CONSERVATION DEPARTMENT DETAILED AGENDA

Date: September 21, 2021

100 Paradise Lane

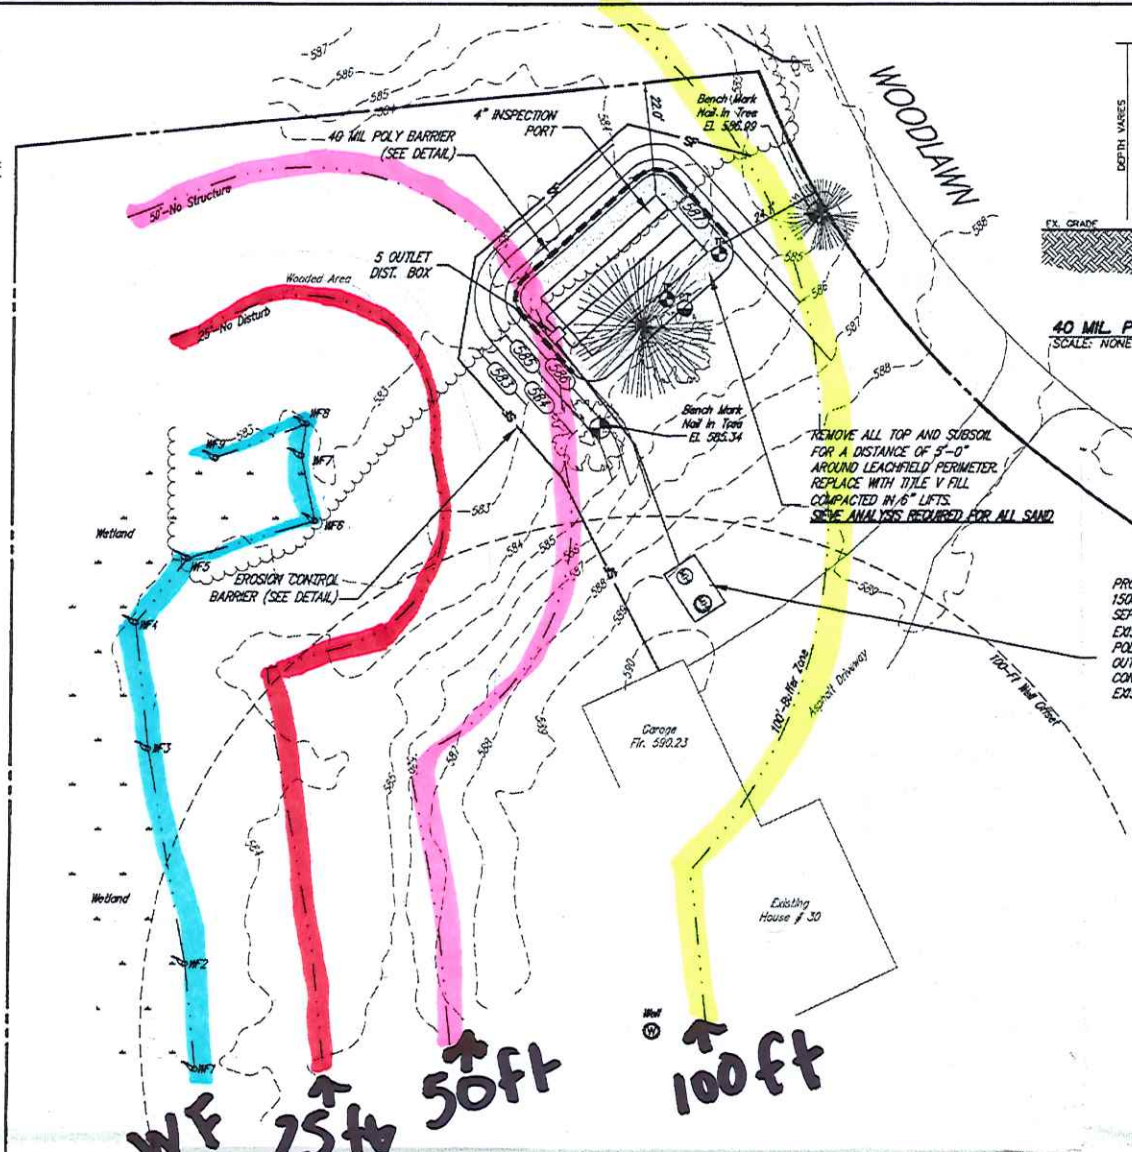
- A revised plan has been received which includes replacing a portion of the proposed impervious driveway with pervious pavers. Additionally, 8 deciduous trees are proposed throughout the site.

- In regards to DEPs comments, staff have requested additional information related to the Bank work. Work includes the enhancement of the natural bank with additional boulders where erosion is occurring and the replacement of existing damaged stairs. Narrative provided.

- Based on the work, it would not appear that a wildlife habitat evaluation would be required as outlined in 321 CMR 10.54(4)(a)(5) as this is primarily a bank enhancement project and will not result in a significant impact to wildlife habitat. Only a few sections for boulder enhancement. Stairs to be replaced in the same location. Project includes additional plantings to enhance the 25 foot No Disturb Zone.

- It appears that the applicant has taken steps to address the board's concerns. The SCC should evaluate the revised plan to see if it addresses the raised concerns. Staff recommend an O & M plan for the pervious pavers per the manufacture's recommended maintenance recommendations.

- Staff Recommendations: If the missing information is submitted (filing fee) then the board can vote on the project otherwise it is still incomplete. If missing information is not submitted, then project needs to be continued so they can provide it or denied for lack of information.
